- 6. Nikiski North Subdivision Dyer Addition**  
**KPB File 2024-034**  
**Segesser Surveys / Dyer**  
**Location: Hinson Avenue & Bohlin Street**  
**Nikiski Area / Nikiski APC**

ITEM #6 - PRELIMINARY PLAT  
NIKISKI NORTH SUBDIVISION DYER ADDITION

STAFF REPORT

## Nikiski North Subdivision Iyer Addition

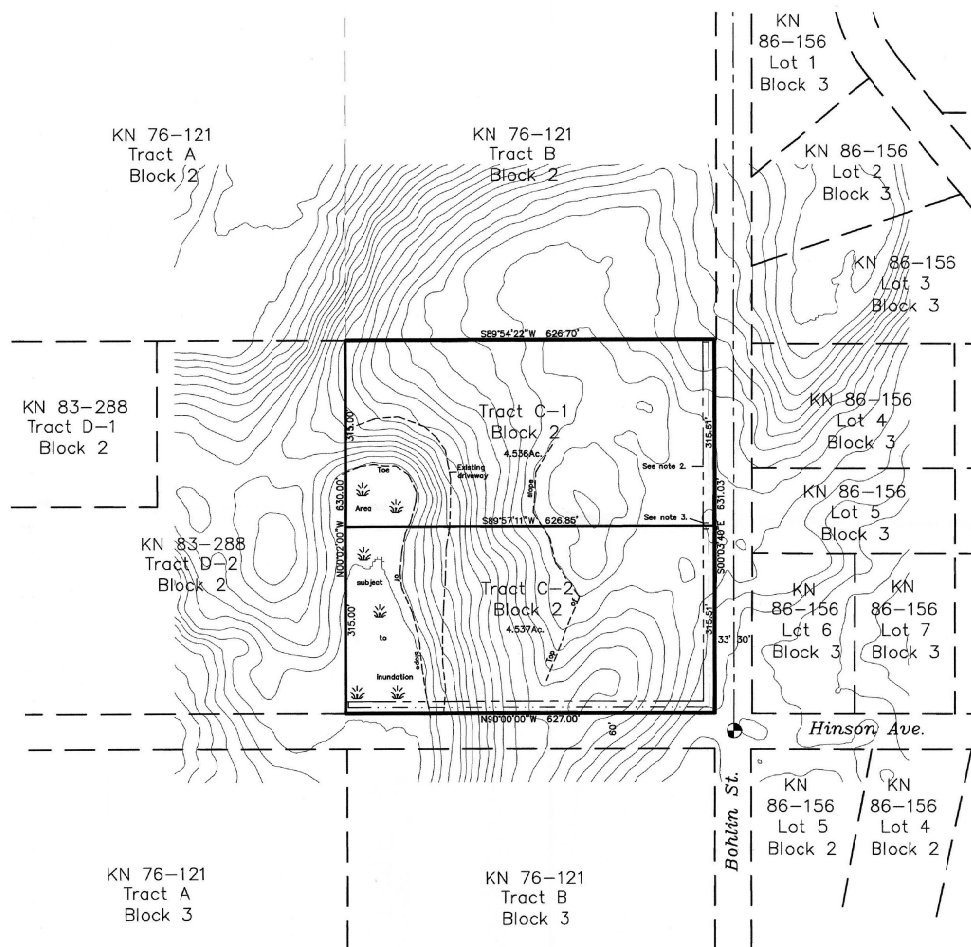
There is a private drive shown on the drawing coming from the south into the property that crosses both tracts and turns west to the property next door. There is no easement listed in the certificate to plat for this driveway. It would be suggested that access easements be drawn up amongst the owners of these two tracts and adjacent properties using this private drive for continued joint use of the drive.

The subdivision is affected by a section line easement located in Bohlin St on the east side of the plat. **Staff recommends:** the surveyor label the section line easement on the drawing on both sides of the section line.

There are steep areas shown on the plat. the contours identify the area of steepness and the top and toe of slope show the direction of the slope. The contours can be removed for the final but the labels of top and toe of slope

should be left on the final submittal.

HEA has submitted a comment concerning an underground primary electric line following the existing drive crossing the property and having the line either located or a note added about it being the center of a 15’ wide easement. A copy of the comment is in the packet.

- *The icons in the legend are not all used and should be removed if not planned to be.*
- *Plat note #1 states the basis of bearing is from 86-156 KRD, no bearing matches from that plat can be identified, please verify the basis of bearings.*

Add to KPB no. 2024-034

Add the area to the title block

Add Golik Ln and width to the east

Add the adjacent road names closer to the subdivision north and west.

Add road names adjacent to site and to get to site.

Tie subdivision to BLM monuments

Label monuments with full information on cap

Label found and set monuments
